**Proposed Temporary Private Vehicle Park (Private Cars) for a Period of 3 Years in
“Village Type Development” Zone, Lot Nos. 537 (Part), 538 (Part), 540 S.A (Part)
and 541 S.A (Part) in D.D. 218, Ma Kwu Lam Village, Sai Kung North, New Territories
(Application No. A/NE-SSH/155)**

Further Information for Planning Application Nos. A/NE-SSH/155&156**Response-to-Comment****Comments from Drainage Services Department received on 28.3.2024**

Further Information (4) for Planning Application Nos. A/NE-SSH/155**Response-to-Comment****Comments from Drainage Services Department received on 31.5.2024**

Viewpoint 2

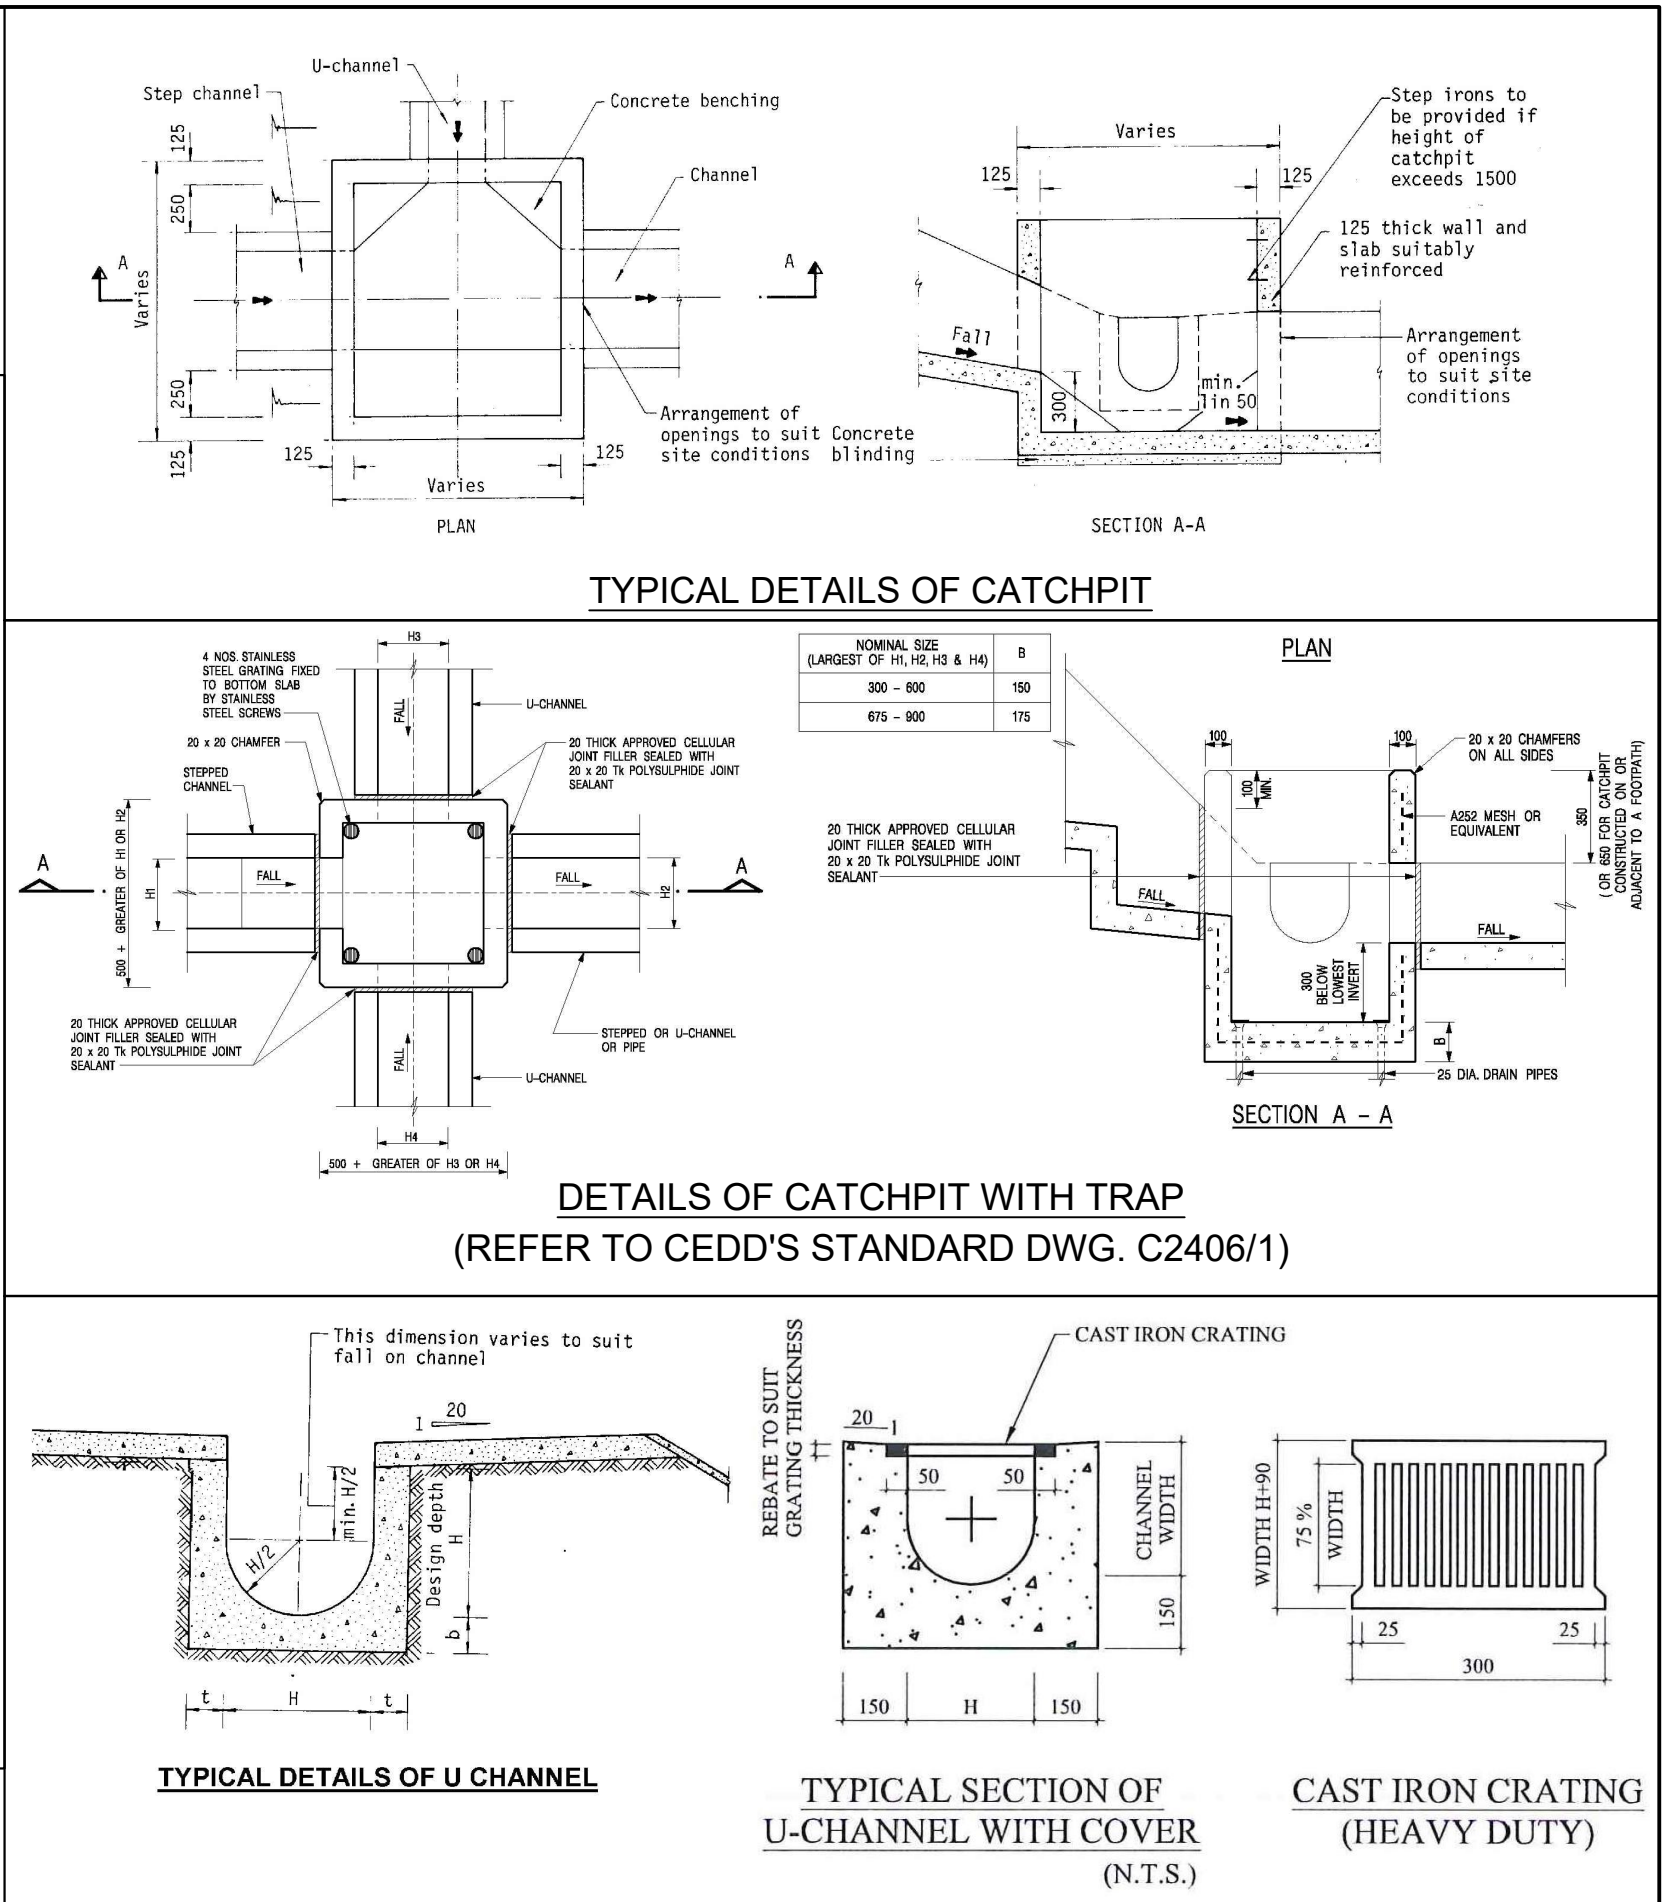
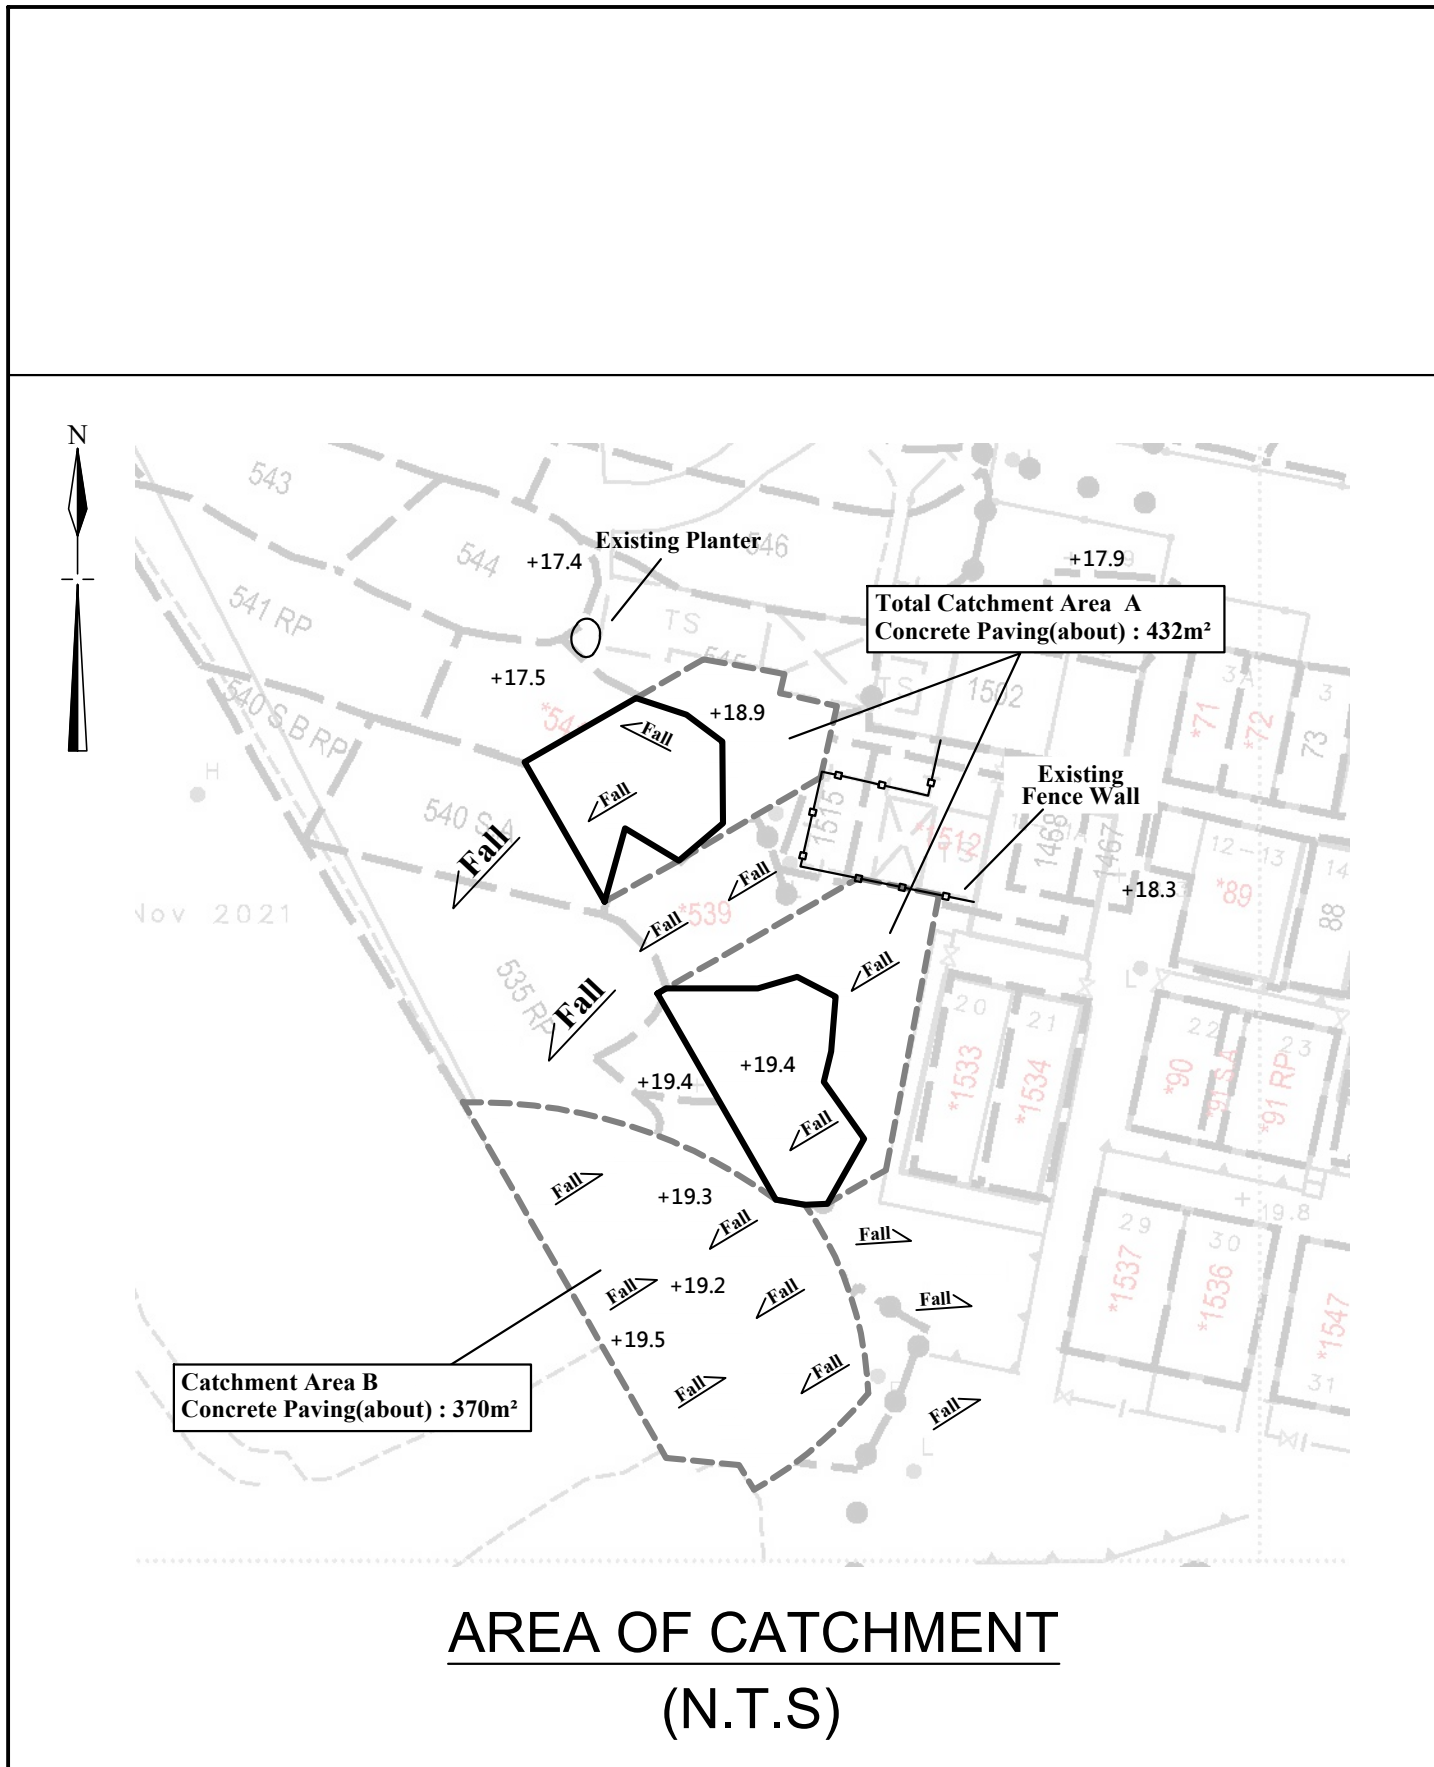
I.	Comment	Response
(a)	Supporting calculations to demonstrate that the existing downstream drain/channel has adequate capacity to convey the runoff to be discharged arising from the proposed development. (Checking for existing 300UC and its downstream for SSH_155)	Please refer to updated Drainage Proposal (Plan 4.1b and Plan 4.2b) and drainage calculations for details.
(b)	The drainage flow path from the development to the public drainage system / streamcourse / sea / any recognized drainage facilities should be provided in association with supporting site photos for the captioned submission. (Please provide downstream information of existing 300UC for SSH_155)	Please refer to attached site photo (Viewpoint 2) for details.
